RE: **Approval of Plans (REV 1)**
TDOT Gibson County Maintenance Building
1248 B Manufacturers Row
Trenton, TN 38382

TFM # 21267
Project # 2023-11-09-02
County: Gibson

Revision #1 Drawing Changes

1 NORTH ELEVATION

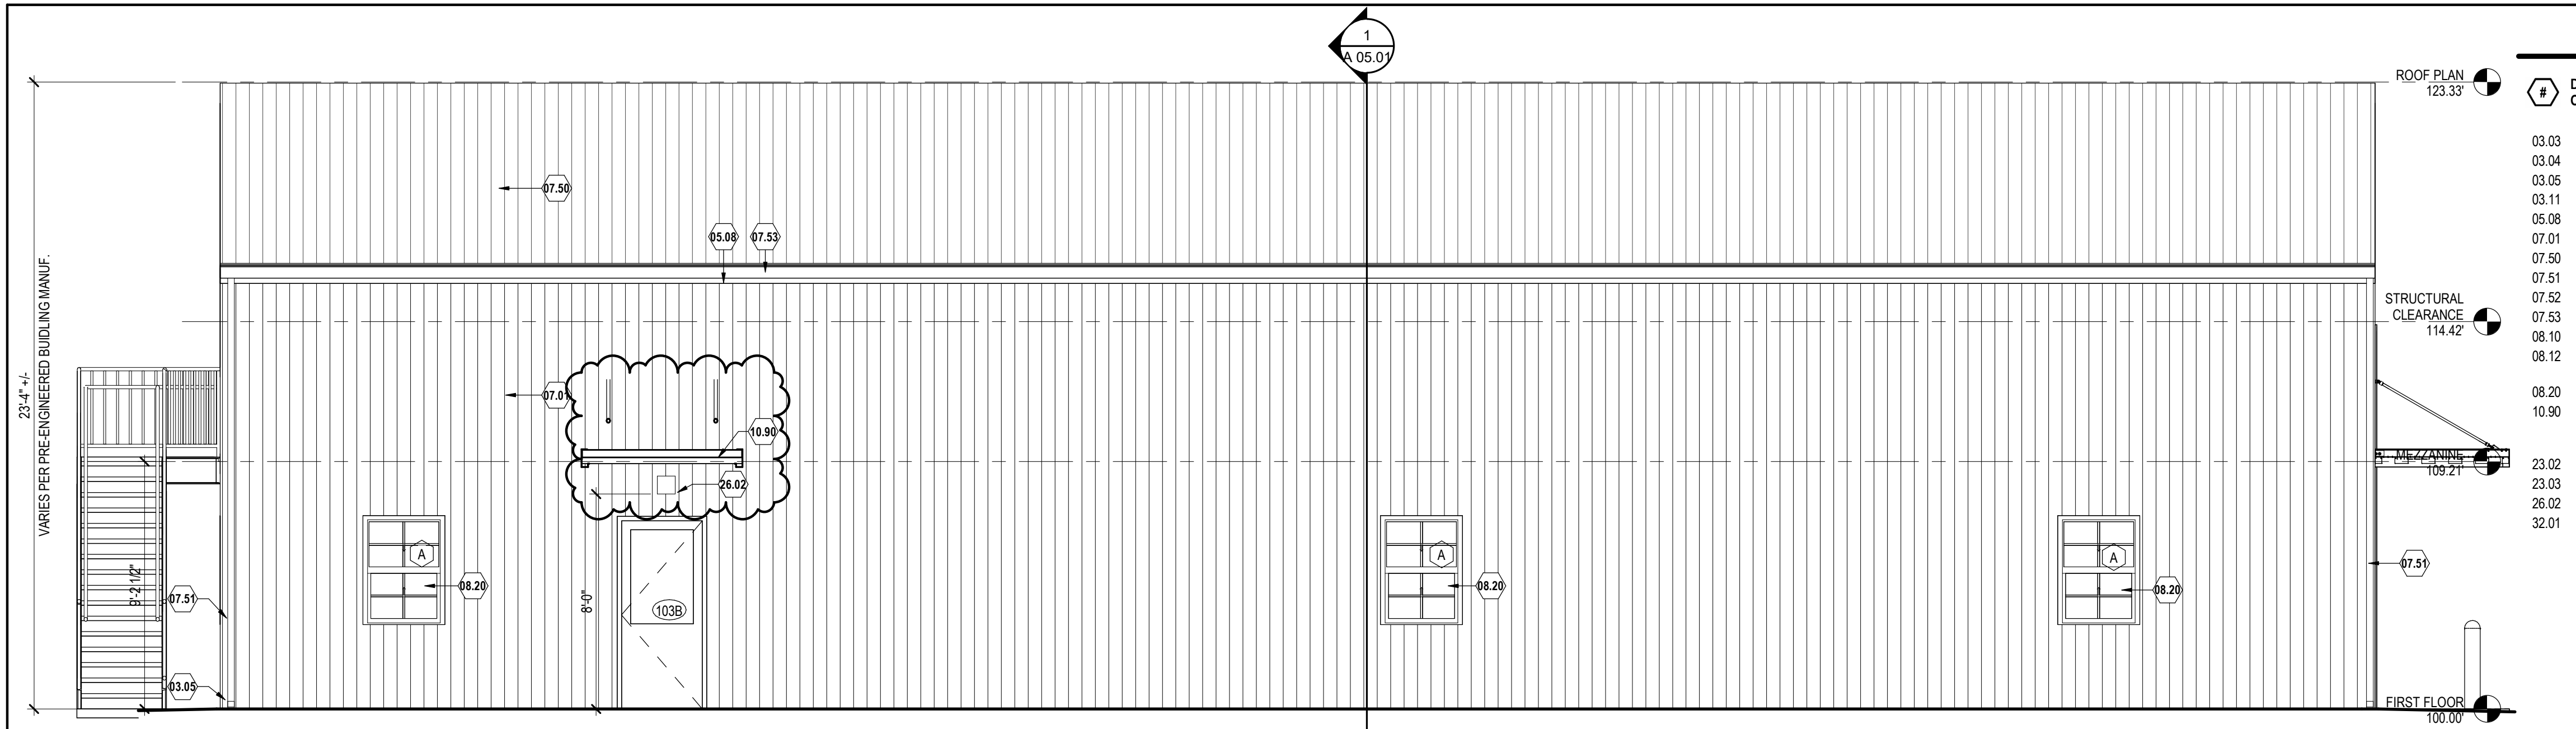
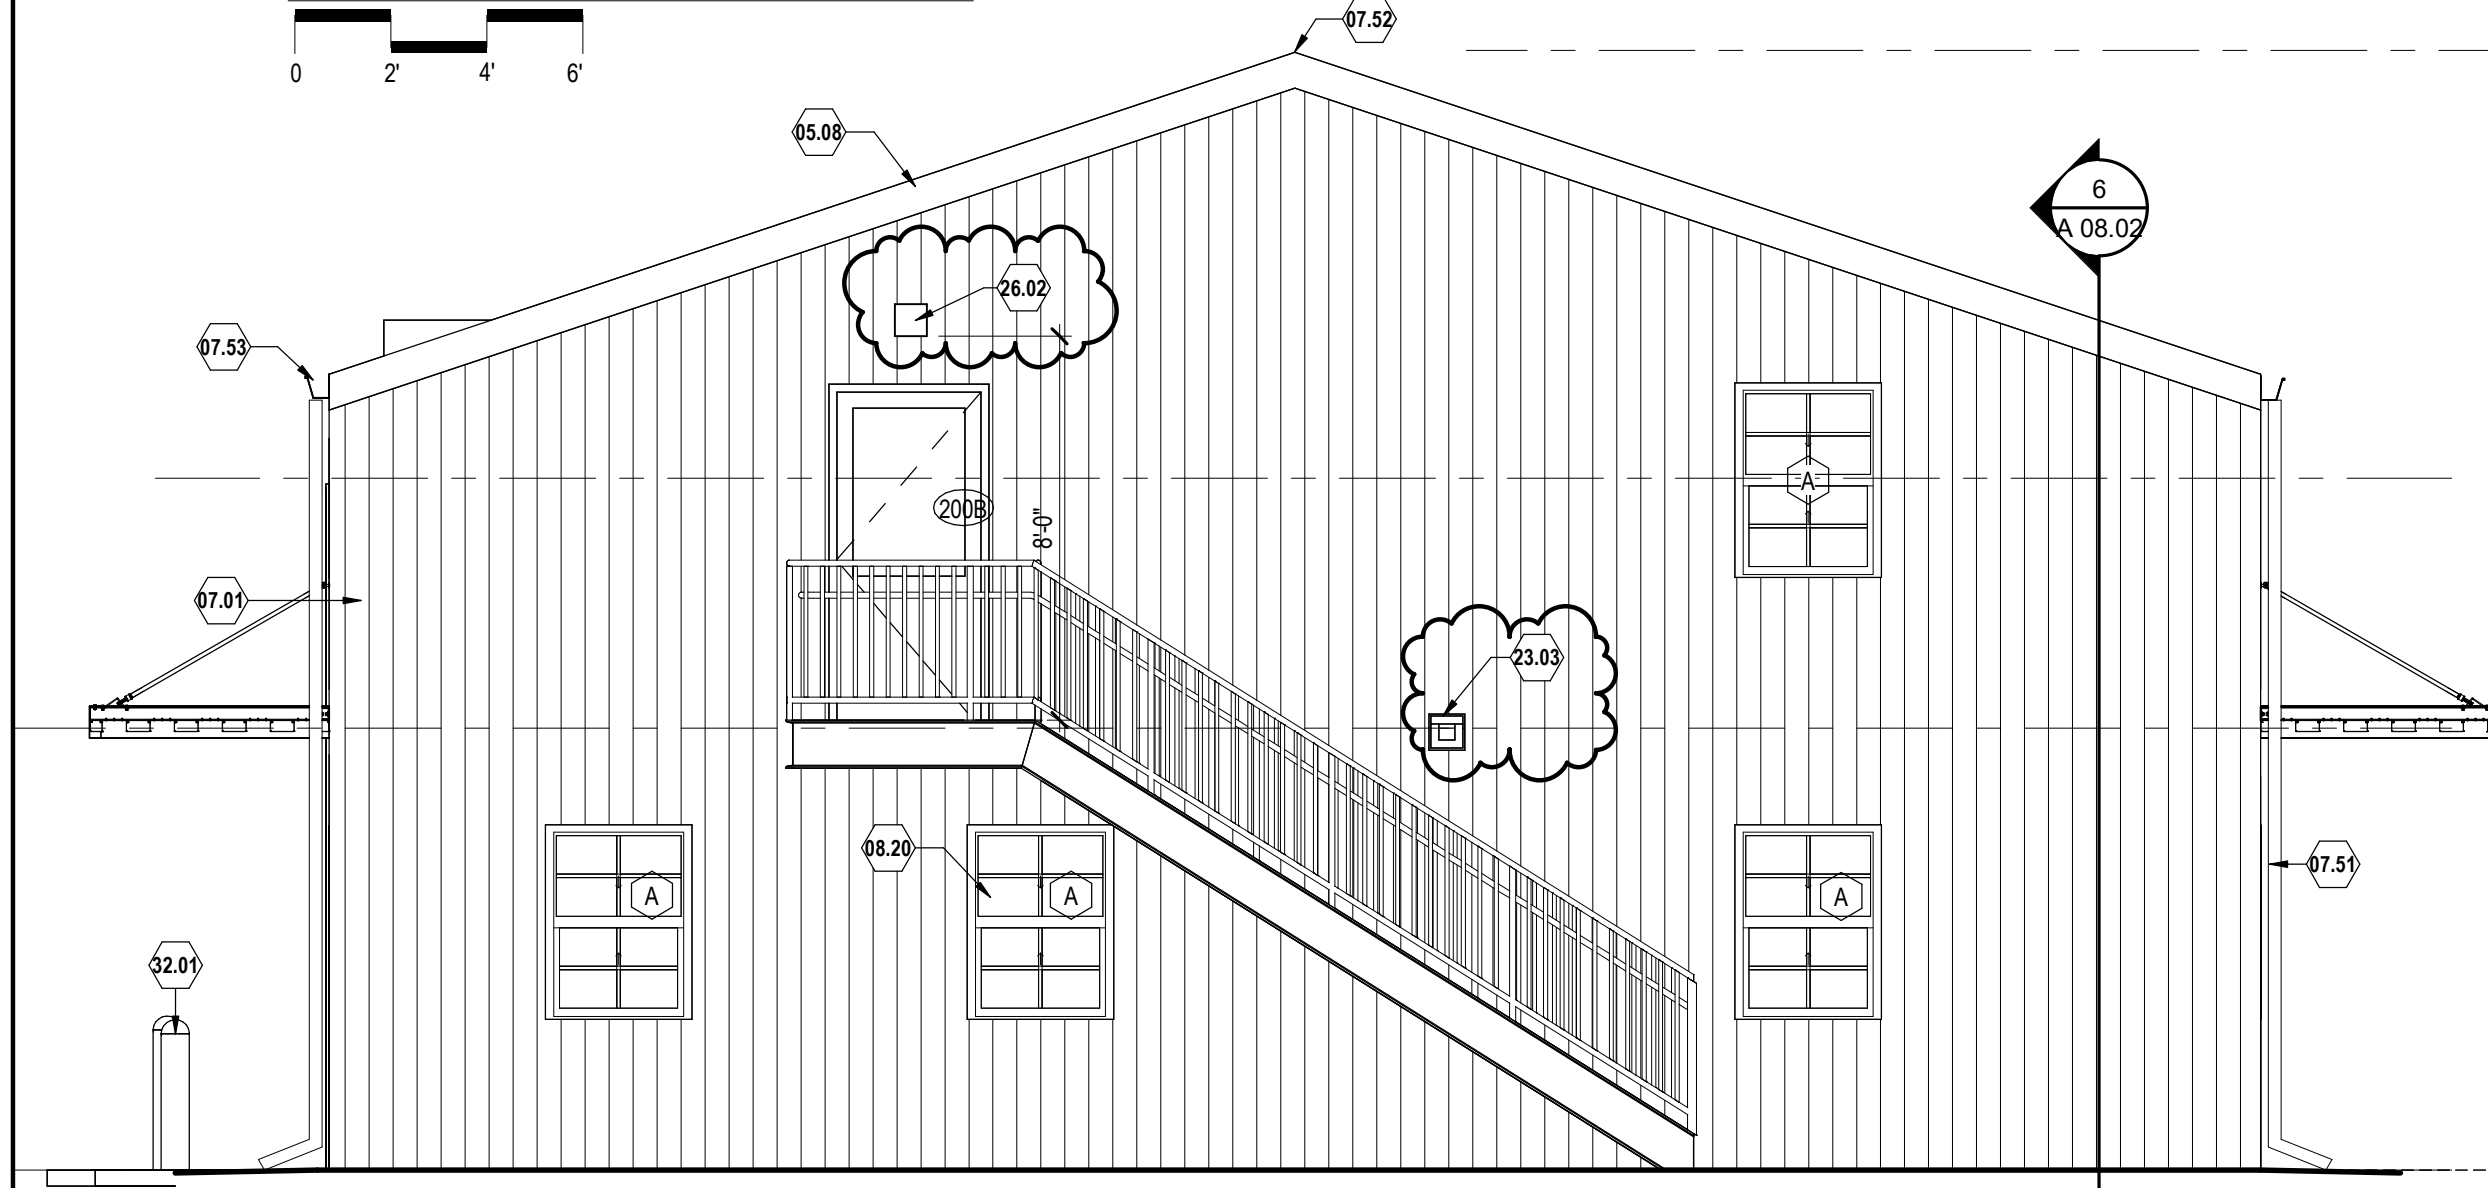
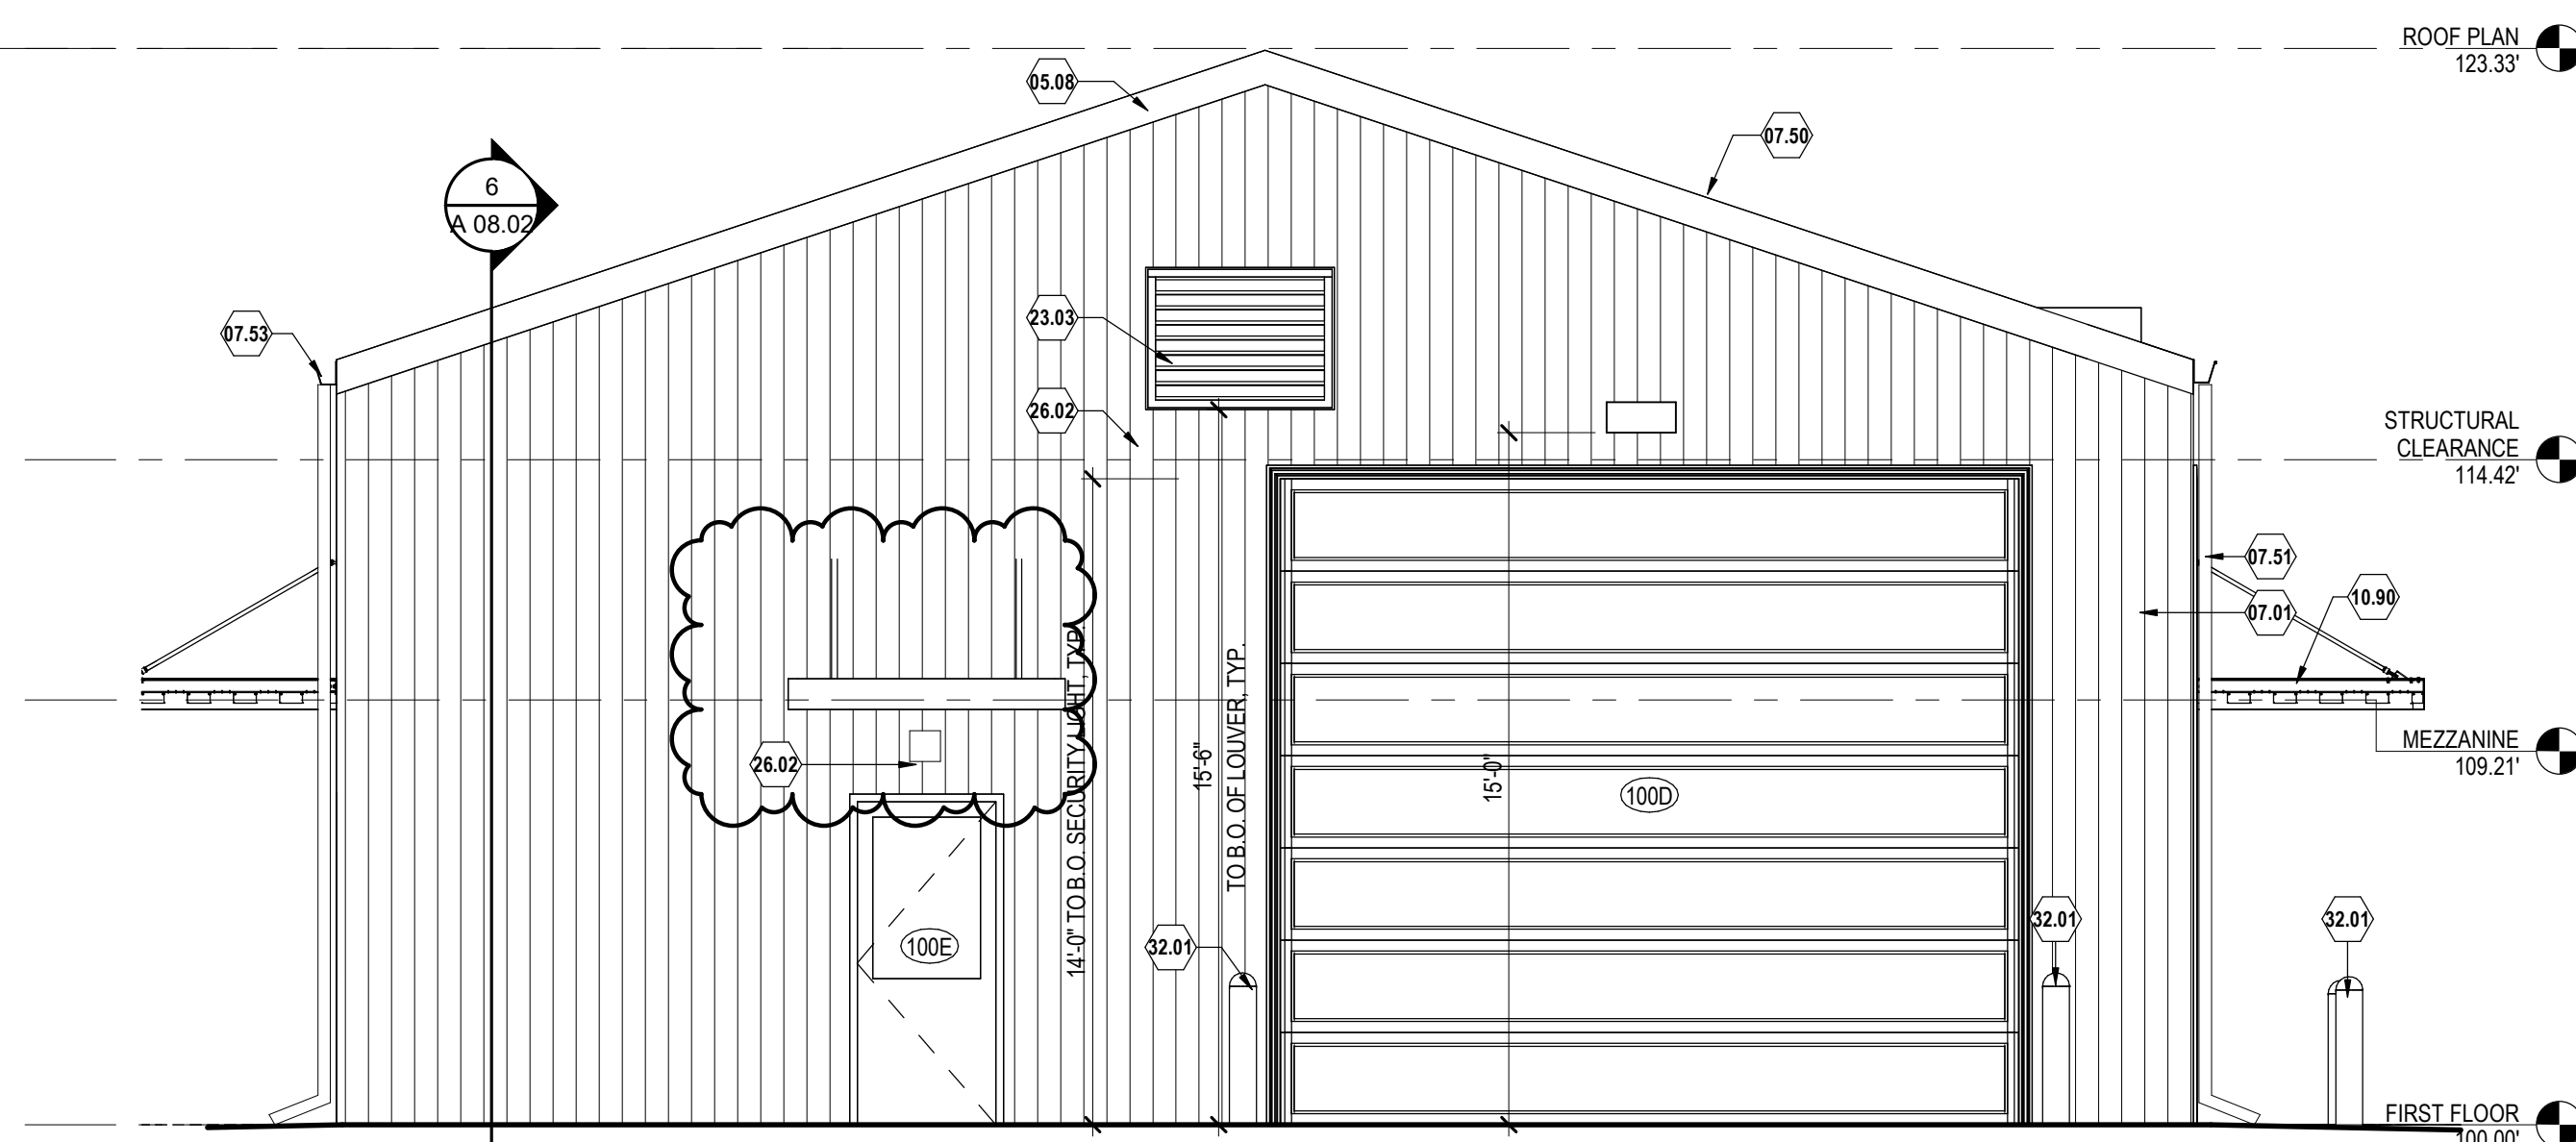
Sheet A04.01: Added canopies over doors on lower level, adjusted lights so that the same type was used over each door, removed louvers no longer needed, and moved one of the lights over the stairs.
